UNITED STATES PATENT AND TRADEMARK OFFICE

Office Action Summary	Application No. 09/913,635	Applicant(s) RUCKERT ET AL	
	Examiner Melody M. Burch	Art Unit 3683

DETAILED ACTION

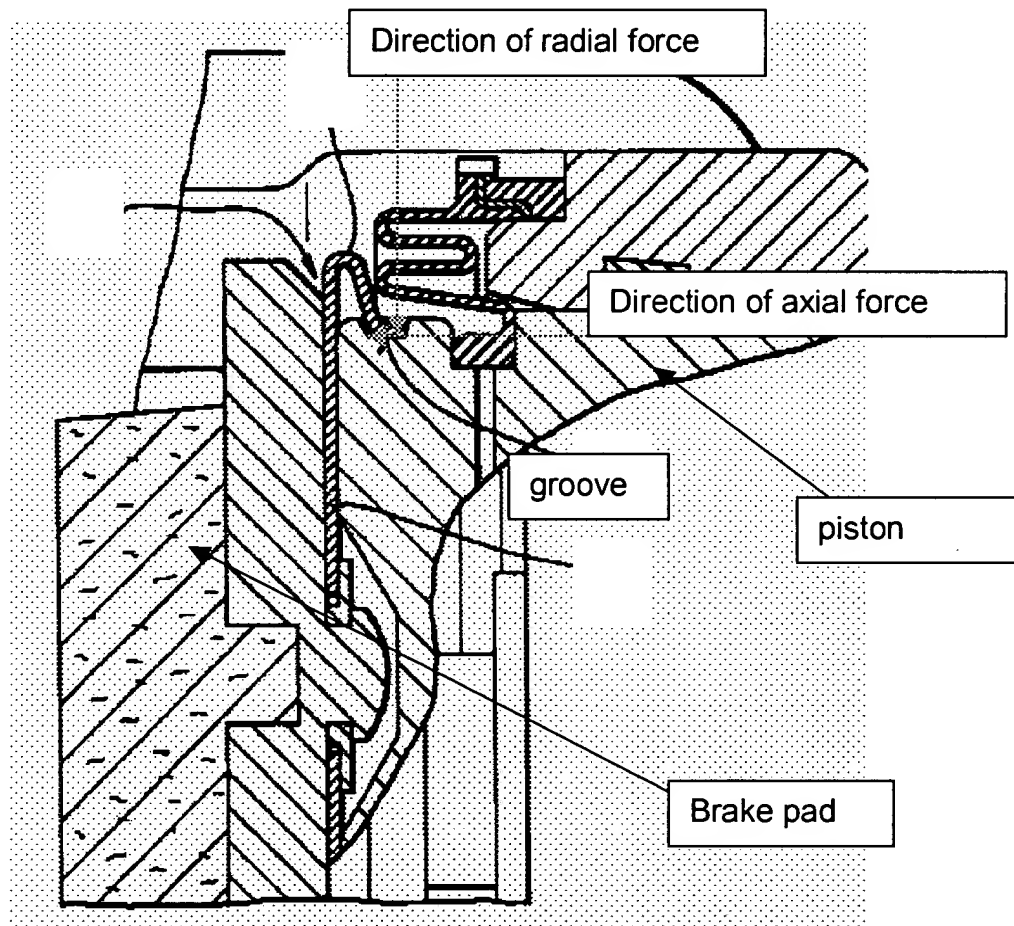
Re: claims 19 and 31. DE'435 shows in figure 5 a brake pad and brake piston assembly comprising a brake piston as labeled in the figure on pg. 3 having an axis and an outer surface encircled by a circumferential groove, a first side 54, second or side 54, and third retaining spring top 54 coupled to a brake pad, wherein the first, second, and third retaining springs engage the circumferential groove as shown, thereby detachably coupling the brake pad to the piston, wherein the first and second retaining springs are arranged opposite each other with respect to the piston axis and wherein the first and second retaining springs each include a spring portion which applies an

axial spring force at a contact point location on opposite sides of the piston to urge the brake pad against the piston, and wherein the third retaining spring includes a spring portion which applies a radial spring force (by virtue of the downward contacting force) to the brake pad at one contact point location in a vertical direction which is generally perpendicular to the piston axis, wherein the first, second, and third retaining springs are separate from one another.

Re: claim 29. DE'435 shows in figure 5 a retaining plate (in an alternate interpretation is the plate connected to the brake pad (in the interpretation of claim 19 the plate connected to the brake pad (lining) is the carrier plate) configured as a damping plate and at least one retaining member shown in the area of element 8 configured as a hook for embracing one of the first second and third retaining springs via the circular portion of element 55 wherein the at least one retaining member is attached to the retaining plate and to at least one of the first second and third retaining springs via the circular portion of element 55.
